Access Compliance Report

Public Rights-of-Way

Intersection ID: 32158	Main Street: MOBERLY_CT	Cross Street: NOLAND_WOODS_DR	Location: SW
ADA ID: 7814812BF1BA	Ramp Type: PerpDiag	Initial Pass/Fail: Fail	Overall Compliance: No
		Severity Score: 10

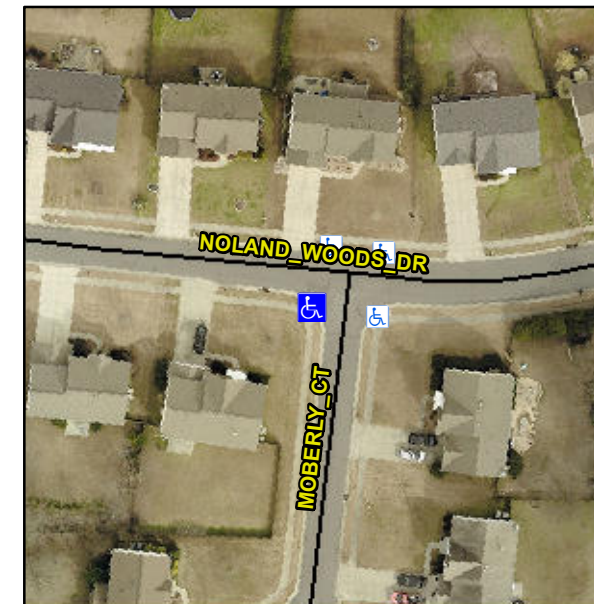
R304.5.1, R304.5.3

Compliance	Description	Data	Compliance	Description	Data
N/A	Ramp Length (in)	46.0	Yes	Ramp Slope (%)	5.2
No	Ramp Width (in)	36.0	No	Ramp XSlope (%)	3.6
N/A	Flare Type LT	N/A	N/A	Flare Type RT	N/A
N/A	Flare Slope LT (%)	N/A	N/A	Flare Slope RT (%)	N/A
N/A	Flare Traversable LT?	N/A	N/A	Flare Traversable RT?	N/A
N/A	Landing Length (in)	N/A	N/A	DWS Provided?	N/A
N/A	Landing Width (in)	N/A	N/A	DWS Contrast?	N/A
N/A	Landing Slope (%)	N/A	N/A	DWS Length (in)	N/A
N/A	Landing X Slope (%)	N/A	N/A	DWS Full Width?	N/A
N/A	Landing Curb? (Y/N)	N/A	N/A	DWS Offset (in)	N/A
N/A	Shared Landing?	N/A			
N/A	Gutter Ponding?	N/A	N/A	Gutter Slope (%)	N/A
N/A	Gutter Lip Ht (in)	N/A	N/A	Gutter X Slope (%)	N/A
N/A	Painted X Walk1?	No	N/A	Painted X Walk2?	No
	X Walk 1 Direction	To SE		X Walk 2 Direction	To N
N/A	X Walk 1 Width (in)	N/A	N/A	X Walk 2 Width (in)	N/A
	X Walk 1 Slope (%)	0.4		X Walk 2 Slope (%)	1.7
	X Walk 1 X Slope (%)	2.5		X Walk 2 X Slope (%)	0.5

Remove & Replace Curb Ramp With Two New Directional Ramps or Equivalent.
